# Access Compliance Report

## Public Rights-of-Way

Intersection ID: 50609	Main Street: DOWNY_BIRCH_RD	Cross Street: PADDLE_OAK_RD	Location: SW
ADA ID: E1104DBEBDFA	Ramp Type: Perp	Initial Pass/Fail: Fail	Overall Compliance: No
Severity Score: 21.25			
Codes/Mitigation Info/Possible Solution		Field Measurements/Component Compliance

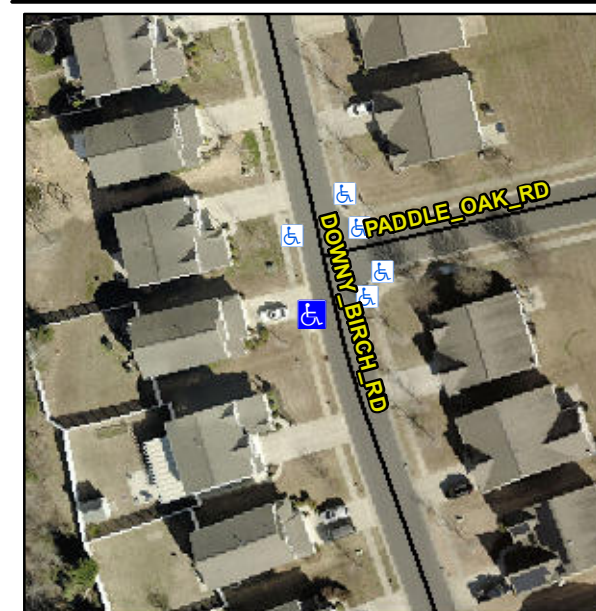
**Not Found, R304.5.1, R304.2.2**

Compliance	Description	Data	Compliance	Description	Data
N/A	Ramp Length (in)	47.5	No	Ramp Slope (%)	10.2
No	Ramp Width (in)	47.5	Yes	Ramp XSlope (%)	0.3
N/A	Flare Type LT	N/A	N/A	Flare Type RT	N/A
N/A	Flare Slope LT (%)	N/A	N/A	Flare Slope RT (%)	N/A
N/A	Flare Traversable LT?	N/A	N/A	Flare Traversable RT?	N/A
N/A	Landing Length (in)	N/A	N/A	DWS Provided?	N/A
N/A	Landing Width (in)	N/A	N/A	DWS Contrast?	N/A
N/A	Landing Slope (%)	N/A	N/A	DWS Length (in)	N/A
N/A	Landing X Slope (%)	N/A	N/A	DWS Full Width?	N/A
N/A	Landing Curb? (Y/N)	N/A	N/A	DWS Offset (in)	N/A
N/A	Shared Landing?	N/A			
N/A	Gutter Ponding?	N/A	N/A	Gutter Slope (%)	N/A
N/A	Gutter Lip Ht (in)	N/A	N/A	Gutter X Slope (%)	N/A
N/A	Painted X Walk1?	No	N/A	Painted X Walk2?	N/A
	X Walk 1 Direction	To E		X Walk 2 Direction	N/A
N/A	X Walk 1 Width (in)	N/A	N/A	X Walk 2 Width (in)	N/A
	X Walk 1 Slope (%)	3.1		X Walk 2 Slope (%)	N/A
	X Walk 1 X Slope (%)	0.3		X Walk 2 X Slope (%)	N/A

**Remove & Replace Entire Ramp.**
